CITY OF ST. AUGUSTINE HISTORIC ARCHITECTURAL REVIEW BOARD

**CITY OF ST. AUGUSTINE HISTORIC ARCHITECTURAL REVIEW BOARD
STAFF REPORT AND RECOMMENDATION
Prepared for April 18, 2024 Meeting**

Application HP2024-0015

Address: 101 Marine Street

Sheet Number **A3.01**

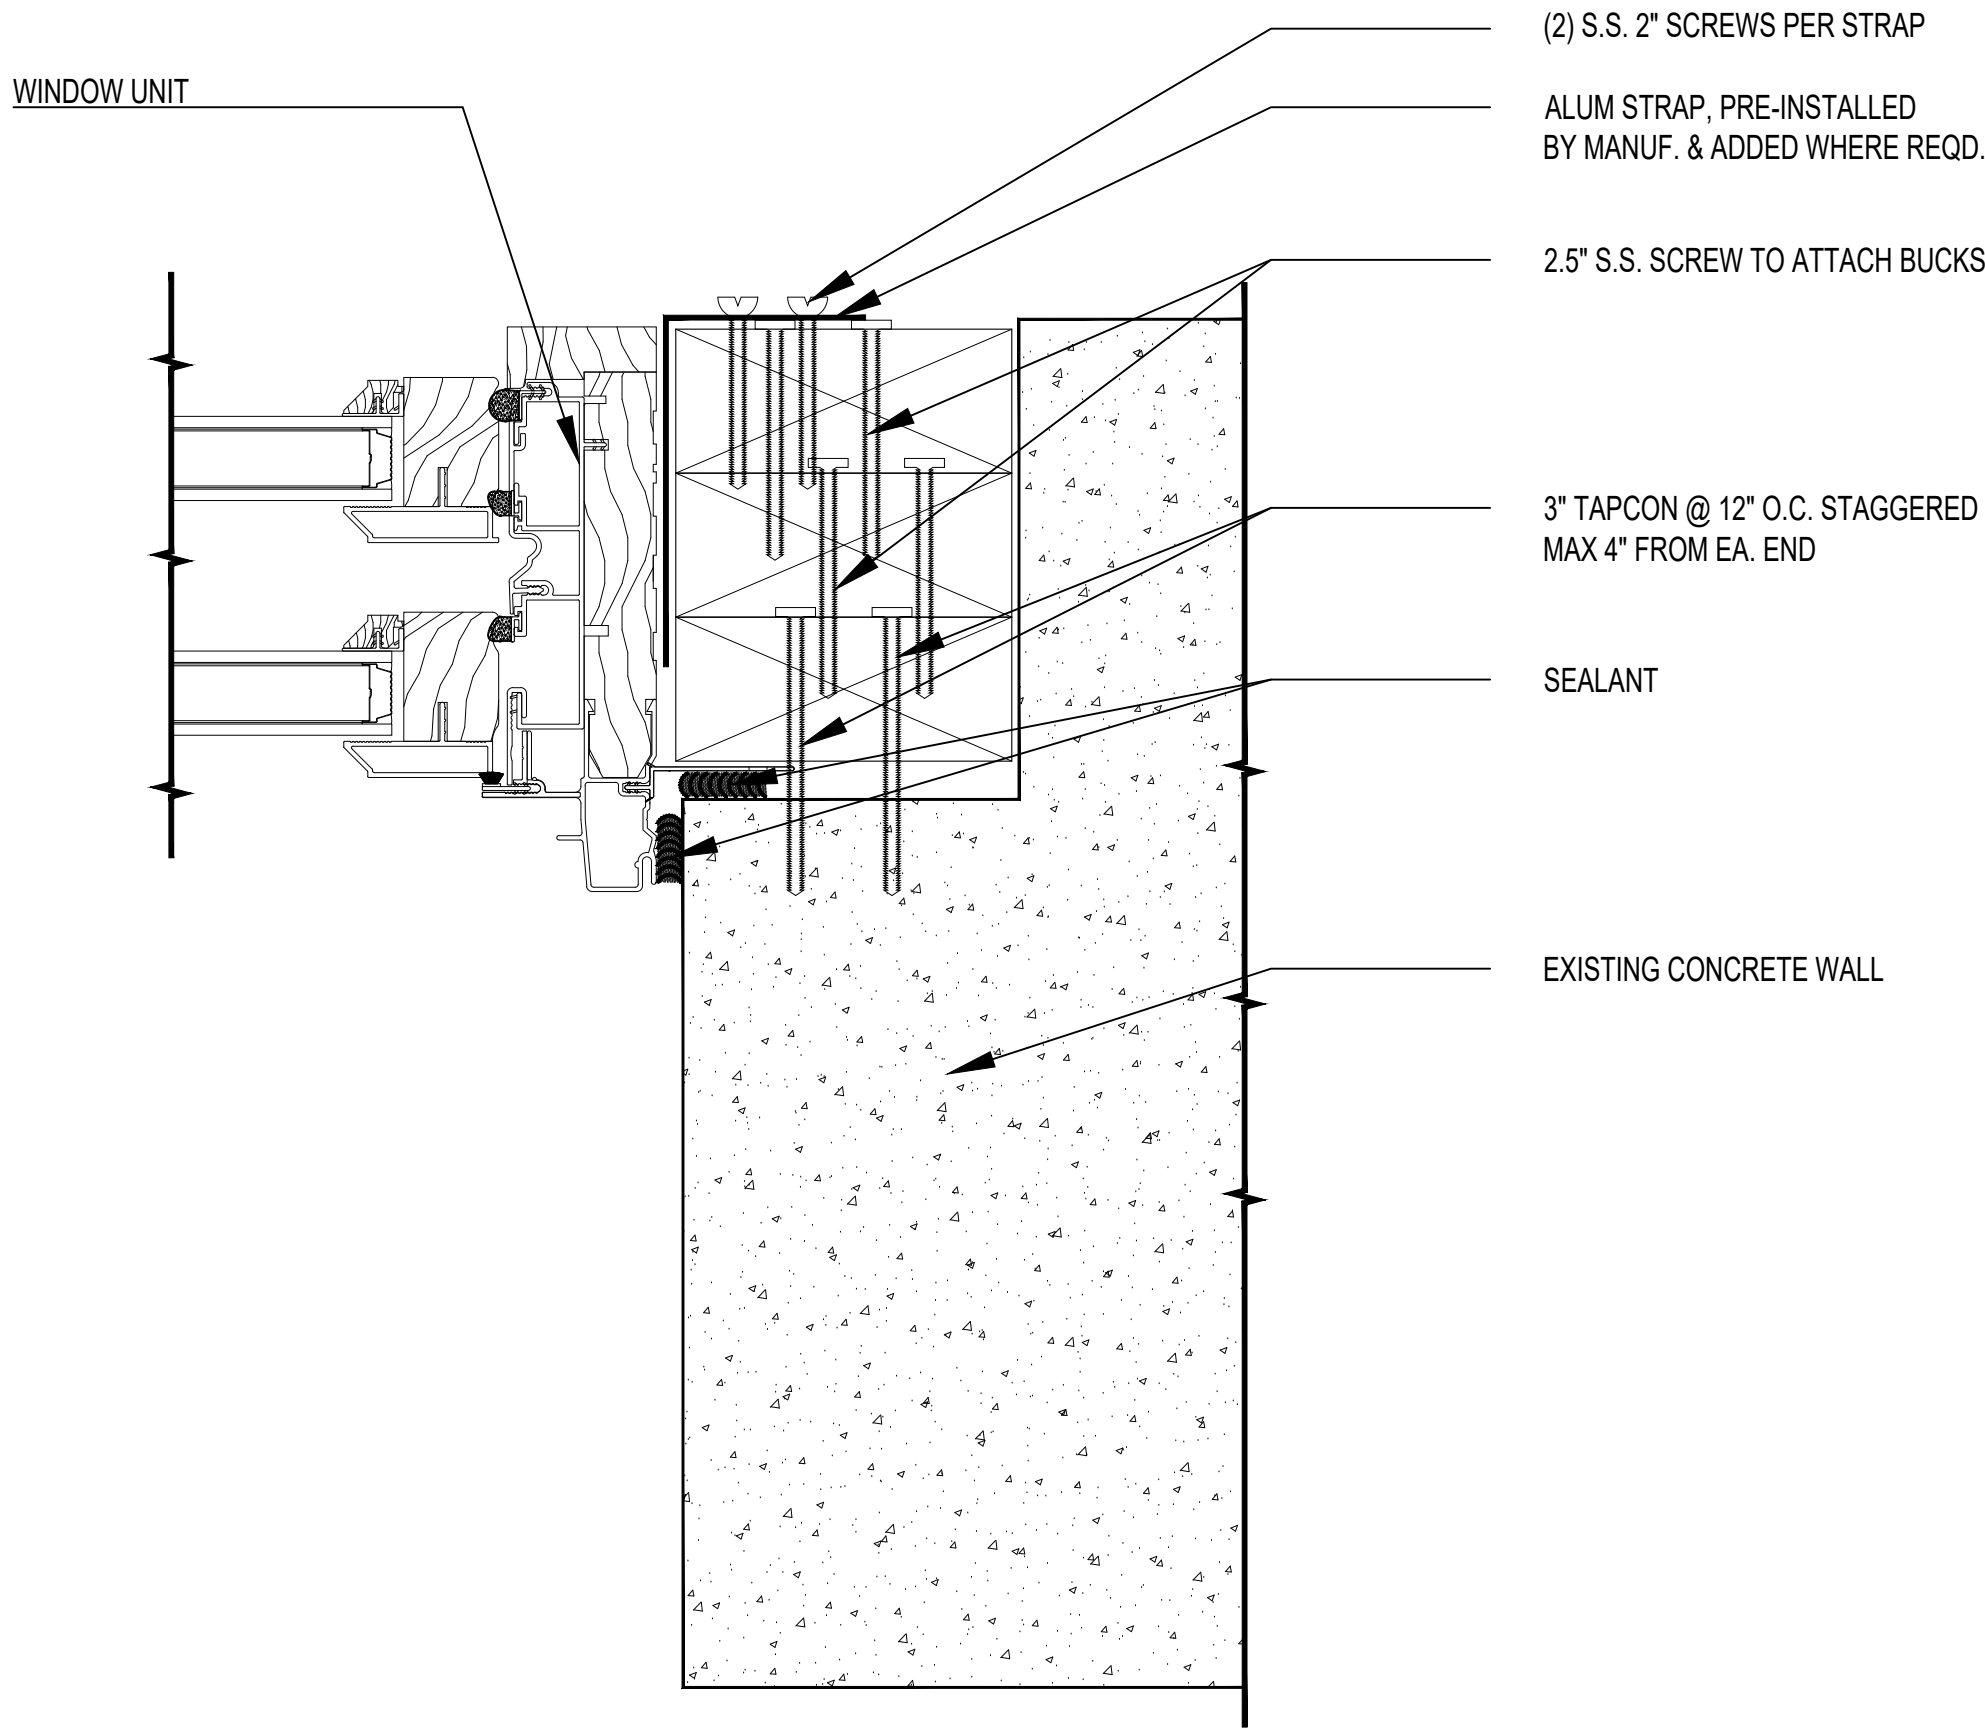
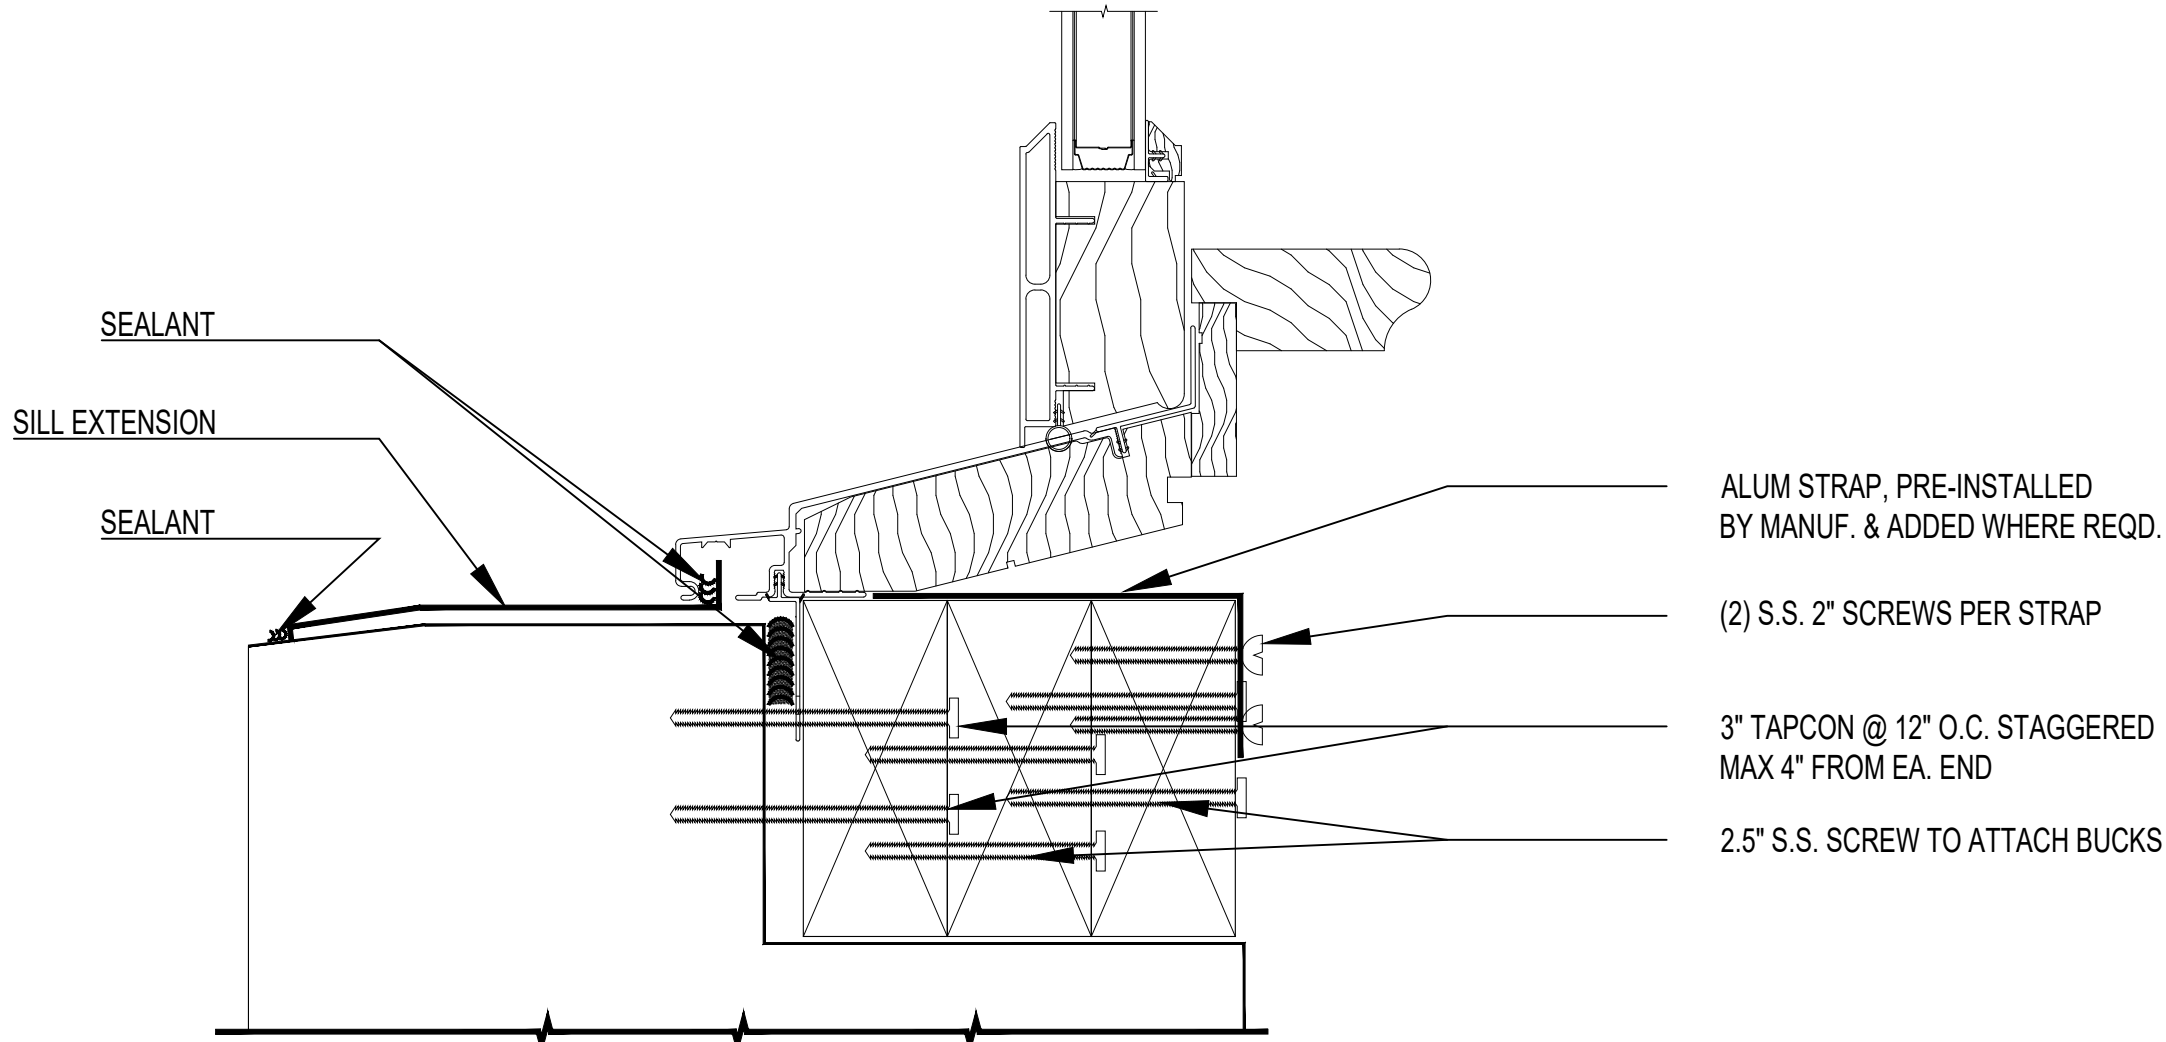
The one thing that I must be not understanding visually on Sheet A3.01 is how the concrete wall is not shown as being cut to receive the window, as there clearly is a notch in the concrete wall's depth, unless the window buck is the coquina concrete.

- Installation details specific to the Alcazar and show how the window will sit within the opening:
 - On Sheet A3.01: Are these generic installation drawings from Kolbe (not specific to the Alcazar?)
